SERVICE LETTER No. 099

Exhaust Bypass Valve FAA PMA Replacement Part

Figure 1 - Exhaust Bypass Valve P/N 470842-0009

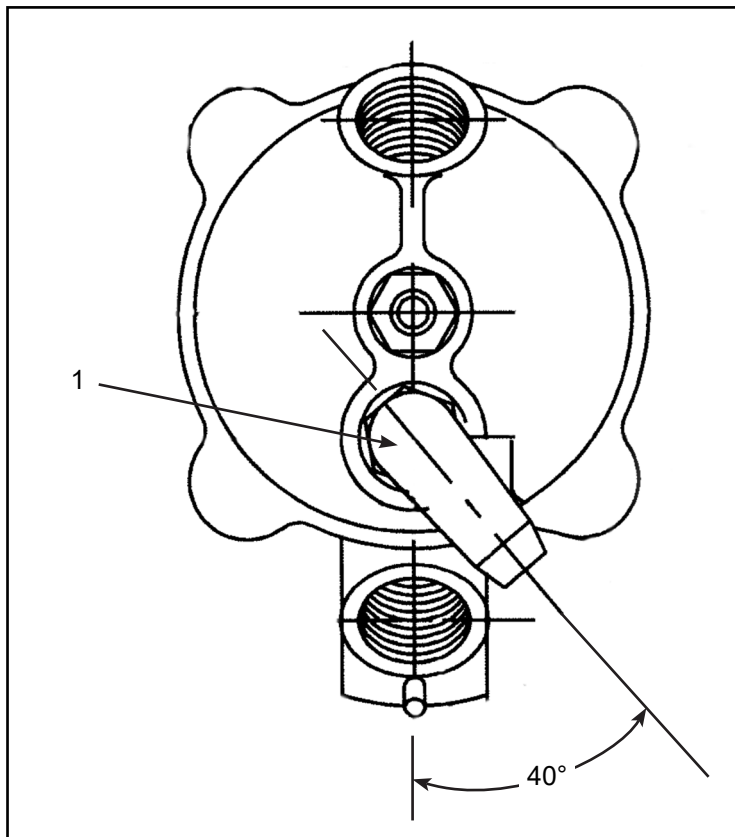
- A. Refer to HET Manual 400999-0000, Rev. C, page 7-460-01 for replacement items, same as P/N 470842-0008, with the following changes for exhaust bypass valve P/N 470842-0009.

- (1) Add Fitting, Elbow (1) P/N MS51527B4, 1 ea.
- (2) Add O-Ring (2) (not shown) P/N 60003. Used with Fitting, Elbow (1). 1 ea., Replace whenever Fitting, Elbow (1) is removed.

- (1) Add the following steps for exhaust bypass valve P/N 470842-0009:
 - (a) Pg. 3-310-01, between steps s. and t., add:
 - 1) Install the O-ring (2) onto the elbow fitting (1), careful not to cut or nick the O-ring (2).
 - 2) Apply a thin coat of engine oil to the O-ring (2) and install the elbow fitting (1) with O-ring (2) into the oil inlet port.
 - 3) Orient the elbow fitting (2) at 40 degrees as shown in Fig. 1 and torque to 7-9 ft-lbs.
